Traffic Calming (Speed Humps) - Bala Avenue

Date: April 25, 2024

From: Director, Traffic Management, Transportation Services

Attachment 2: Speed Hump Locations Plan - Bala Avenue

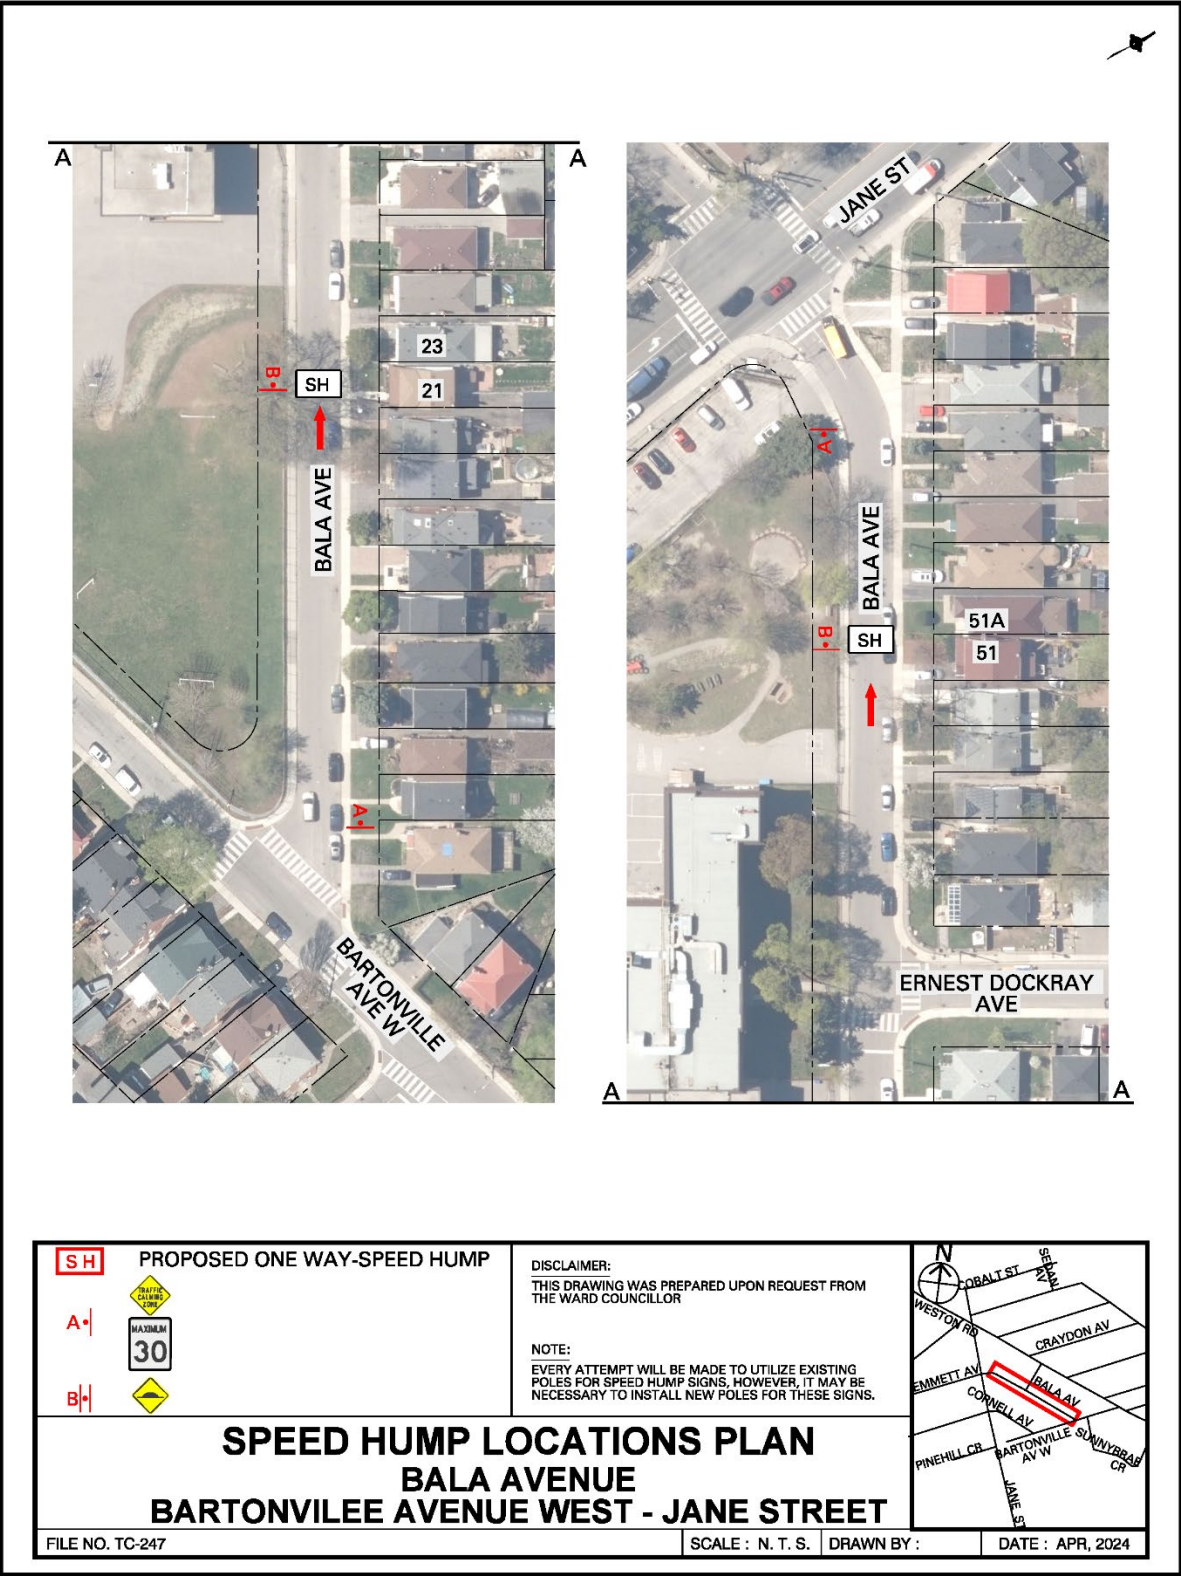
Toronto Fire Services does not support this proposed speed hump installation as it may negatively impact service delivery. The physical restrictions imposed by speed humps have a greater impact on fire vehicles. Response time increases with every obstacle encountered responding to any emergency incident and the cumulative impact of several speed humps can increase responses times.

Toronto Fire Services is supportive of initiatives that improve safety for all citizens and visitors to the City of Toronto. However, careful consideration must be given to accepting a delay to emergency response vehicles as a compromise to combat the risks presented by all vehicular traffic. Our recommendation is that non-physical measures be considered and evaluated to determine if desired results can be obtained without imposing a physical obstacle to emergency vehicles.

Bala Ave appears to primarily service the residents that reside on the roadway and would not impact response times for other community members. It is important that the applicant understand that the installation of traffic calming devices will reduce the speed that emergency vehicles travel when responding to emergencies on roadways where they are installed.
